Petition: x1313  
"REVISED"

### **NOTICE OF PROPOSED CHANGE IN PROPERTY**

**REQUEST ENCROACHMENT  
 INTO W. GRAND BLVD. AND THIRD AVE.  
 AT 2921 W. GRAND BLVD.  
 (With Planters and Sub-Surface Frost Slabs)**

**CITY OF DETROIT**  
 CITY ENGINEERING DEPARTMENT  
 SURVEY BUREAU  
 JOB NO. 01-01  
 DRWG. NO. X 1313

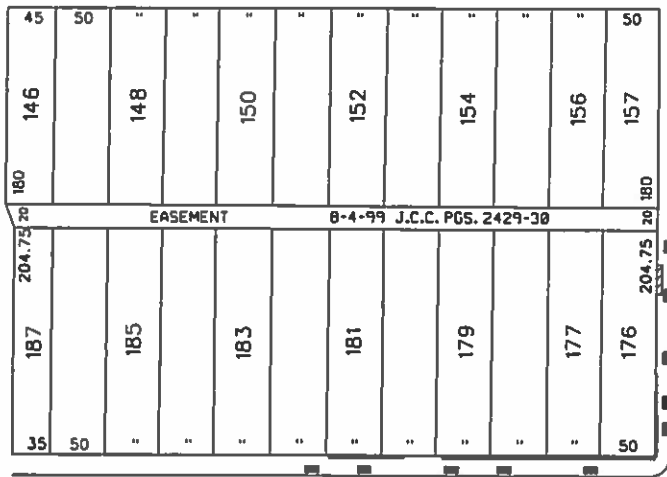
- Not Involved  
Third revision to petition requesting encroachment for frost slabs and planters along W. Grand Blvd. and Third St.
- Involved; but asking you to hold action on this petition until further notice.
- Involved; but no objections to the property change.
- Involved; but no objections to the property change...provided as easement of the full width of the public right-of-way (street, alley or other public place) is reserved.
- Involved; the nature of our services and the estimated costs of removing and/or rerouting such services are:
